MEMORANDUM

SUBJECT: Case 21084: Application for a development agreement to permit the sale and

installation of automotive accessories at 429 Cobequid Road, Lower Sackville

PLANNING APPLICATION CASE NO. 21084

Figure 2 – Development plan

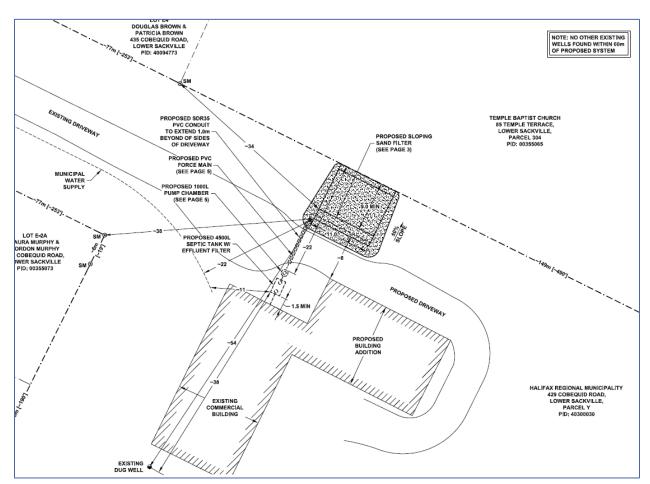
The development, shown in Figure 2, is proposing an expansion of 3875 sq. ft. to the existing 5340 sq. ft. building, for a total of 9215 sq. ft. It should be noted that the existing building is currently not in service and does not generate any traffic on Cobequid Road.
